PARTS & SERVICE NEWS

REF NO. AA03007

- SUBJECT:** CRACKING IN STEERING ACCUMULATOR TO BLEEDDOWN MANIFOLD TUBING
- PURPOSE:** To inform the field of a kit for replacing accumulator to bleeddown manifold tubing with flexible hoses.
- APPLICATION:** Komatsu Mechanical Drive Dump Trucks:
530M: A30001 thru A30038, 32628;
HD1500-5: A30039 and Up
- FAILURE CODE:** 6A01HA
- DESCRIPTION:** Steering Accumulator Tube Replacement Kit (XK0183)

FIGURE 1. STEERING ACCUMULATOR TO BLEEDDOWN MANIFOLD TUBES

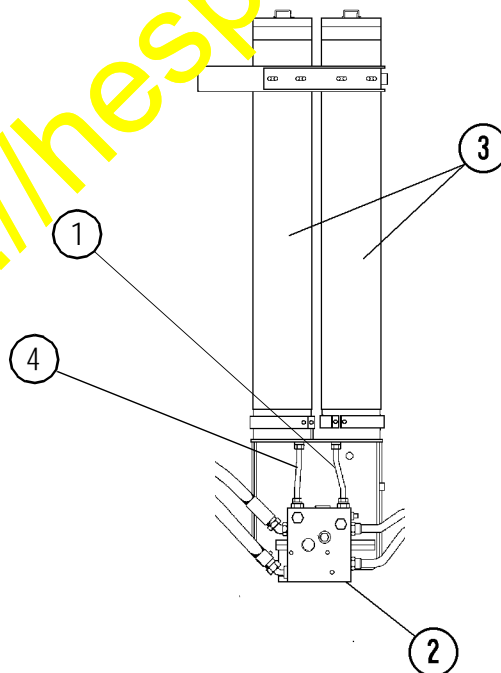
Some trucks in the field may experience cracking of tubes (1 & 4, Figure 1) that connect the steering accumulator to the bleeddown manifold. The short length of the tubes along with alignment difficulties can cause excessive stress on the tubes, resulting in tube cracks.

Steering Accumulator Tube Replacement Kit (XK0183) has been developed to replace the tubes with flexible hoses. The use of longer, flexible hoses requires some changes in hookup and porting on the bleeddown manifold. These changes, along with additional instructions, are outlined on the installation drawing (EK4826) included in the kit and shown on page 3 of this bulletin. Refer to Table 1 for a complete listing of kit contents.
